16 - 19 October, 2001

Sydney, Australia

Source: QUALCOMM Europe S.A.R.L.

Title: Security concern with HFN reset procedure

Figure 11.4: RLC reset procedure

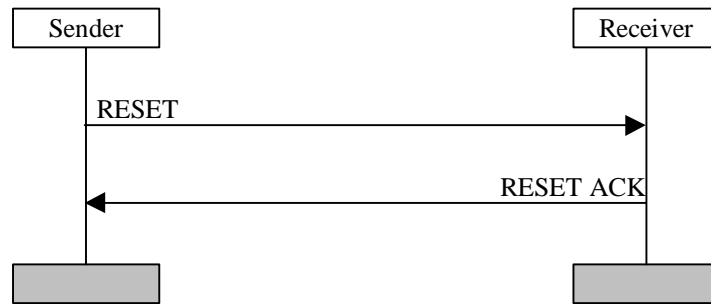
All RLC Control PDUs, including RESET/RESET ACK, are not ciphered and are not integrity protected. The RESET and RESET ACK are always associated to an AM RLC entity and they carry the HFN value to be used in the UL COUNT-C. Both UE and UTRAN can initiate a RESET procedure by sending the RESET PDU. The receiving entity will then send a RESET ACK PDU. We can envisage a multiplicity of security threats that could take advantage of this procedure:

- *Denial of service attack.* A third party can transmit a RESET PDU with an incorrect HFN. The RESET ACK PDU response will be ignored by the supposed sender. From then on, decryption of the packets will result in incorrect and unintelligible data being received, but since there is no integrity check, the lower layers cannot detect or recover from the situation. Furthermore, by setting a large HFN, past the threshold, a new AKA might be triggered, resulting in exhaustion of Authentication Vectors, delays and excessive network traffic.

- *Exposure of HFNs.* If an eavesdropper is recording the call from its beginning he will be able to deduce the HFN values used in COUNT-C. But if he starts recording it while in progress, or if he loses part of it due to bad radio conditions (quite a likely scenario), he may lose track of the current value of the HFN and therefore he will not be able to reconstruct COUNT-C. However, he could take advantage of the RESET procedure to read the correct HFN values being sent in the RESET/RESET ACK PDUs. By the way, to cause a RESET for a "man in the middle" is very simple. He only has to change the sequence number (always in clear) to a value that is outside of the "expected" window of sequence numbers.

- *Rogue equipment can avoid re-authentication.* The COUNT-C value triggers re-authentication when it exceeds the threshold value. But non-conforming equipment can reset the HFN "backwards" so that its COUNT-C never reaches THRESH. This partly avoids re-authentication (it might be triggered by the HFN in the other direction) and at the same time compromises privacy by reuse of COUNT-C values.

We propose that RAN WG2 should take a second look at the problem discussed in [2] and solve it differently, by using methods that do not compromise security. In particular, the use of the RESET/RESET ACK PDUs, which currently include HFN values, should be modified. In order to not modify the PDU format, the transmitter could include dummy HFN values in the RESET/RESET ACK PDUs that the receiver would ignore. These corrections should be included in all affected releases of TS 25.322, starting from R99.

1. The HFN values should not be sent in clear and without integrity protection.
2. If HFN have to be re-synchronized, the new values should grow monotonically; while this is specified behaviour for a conforming transmitter, no provision is made for it to be checked in the receiver. Provision should be incorporated for the re-synchronization procedure to fail or be refused.

Figure 9.6: RESET, RESET ACK PDU

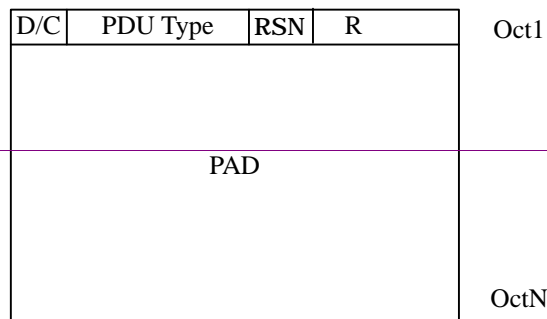
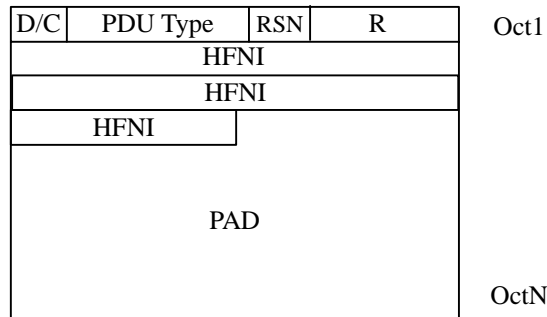
Reason for change:
1. The current RLC reset procedure can lead to unsynchronised hyper frame number (HFN) values between UE and UTRAN, which will lead to ciphering failure as discussed on the email reflector. To correct this mechanism, HFN values are indicated in the RESET PDU and RESET ACK PDU. With this correction, RLC can maintain synchronisation of HFN values during reset.

The RESET PDU and RESET ACK PDU has a one-bit sequence number field (RSN). With the aid of this field the Receiver can define whether the received RESET PDU is transmitted by the Sender for the first time or whether it is a retransmission of a previous RESET PDU..

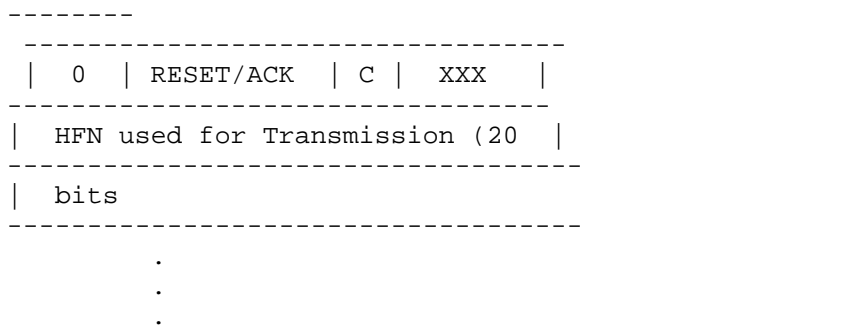
Thus an indication is needed in the RESET PDU to indicate which configuration to be used after resetting the variables.

Thus we think that RESET PDU should indicate

1. Configuration to be used (old/new)
2. HFN to be used

We propose following RESET PDU format and the RESET procedure
